## Flex Tech Quick Disconnect

<b>Bulletin Type:</b>	Recall	<b>Publication Date:</b>	May 2022
<b>Bulletin #(s):</b>	22V-301, 2022-236	<b>Make(s):</b>	Jayco
<b>Job Code(s):</b>	9901577	<b>Model(s):</b>	North Point, Pinnacle, Seismic
<b>Flat Rate(s):</b>	9901577A .10 Inspection Only 9901577B .30 Replacement	<b>Model Year(s):</b>	2021-2022

<b>Incident:</b>	<b>Porosity and contamination of the brass on the Quick Disconnect.</b>
<b>Affected Units:</b>	<b>Certain 2021-2022 Jayco North Point, Pinnacle; Certain 2022 Jayco Seismic</b>
<b>Parts Kit:</b>	<b>Kit#: 22V-301A</b>
	<b>Contents: 1 ea. - Quick Disconnect</b>
<b>Misc. Tools &amp; Supplies:</b>	<ul style="list-style-type: none"> <li>• Soapy Water spray, Wrench</li> </ul>

Fig 1

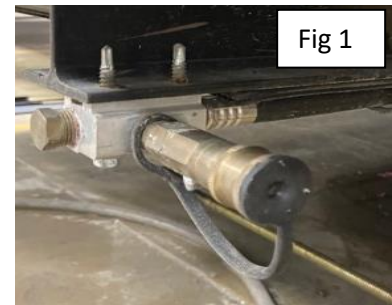
- Inspect the Quick Disconnect at the exterior grill for a black dust cap. (Figure 1) File for inspection only if the dust cap is any other color. Complete repair instructions below if the dust cap is black.

- 1) Replace the Quick Disconnect at the exterior grill location and use soapy water to check if there is an LP leak after installing the new Quick Disconnect.
